Answer to reviewer # 1

“The EUREC⁴A turbulence dataset derived from the SAFIRE ATR 42 aircraft”

Answer to reviewer # 2

Figure R1 : Variance of water vapor mixing ratio computed with the KH20 signal calibrated with the 1011C sensor versus the KH20 signal calibrated with the WVSS2 sensor. The comparison is done for all flight legs from RF09 to RF19.

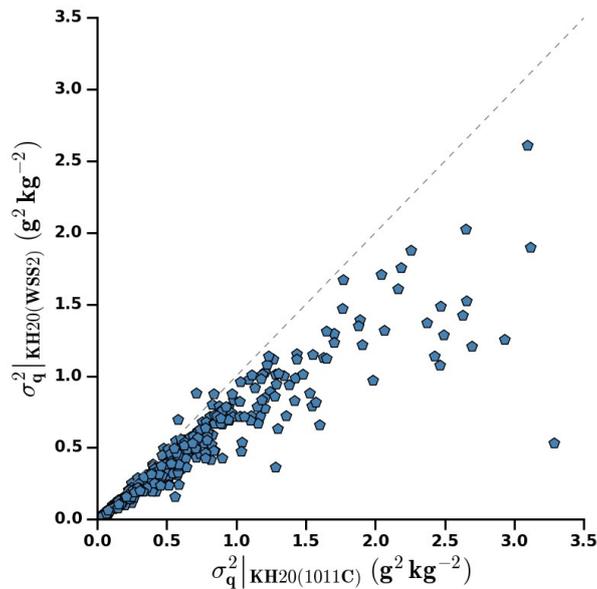
In Figure 2b some variance appears to be forgone in the method of calibration of the (fast) KH20 using the (0.4 Hz) WVSS2 and the (1Hz) 1011C as (competing) references. The cyan trace (1011C) is visible both above the pink trace on crests and below the pink trace in troughs. That may not be noise. Likewise in the spectra of Figure 6 the KH20 and the Li-Cor separate at about 0.4 Hz, just about the report frequency of the WVSS2. I would trust the Li-Cor at least up to 2 Hz. I recommend checking out complementary filtering as a way to link the WVSS2 at low frequencies to the KH20 at higher frequencies. Assuming the WVSS2 data are available from all of the EUREC 4 A flights, this approach is possible using the existing data.

A critical issue in the study was to determine which slow sensor should be most suitable as a reference for calibrating the fast sensors. As you noticed, in Fig. 2b, the amplitudes of the signal calibrated with the WVSS2 is smaller than with the 1011C, suggesting a loss of variance. This, as you also suggested, is not noise. Figure R1 presents the variance of water vapor mixing ratio computed with the KH20 signal calibrated with the 1011C sensor versus the KH20 signal calibrated with the WVSS2 sensor. The variances computed with the 1011C calibration are indeed higher. Nevertheless, after analysis of several legs, we hypothesized that this is actually an overestimation of the variance, when the fast sensor was calibrated by the 1011C sensor.
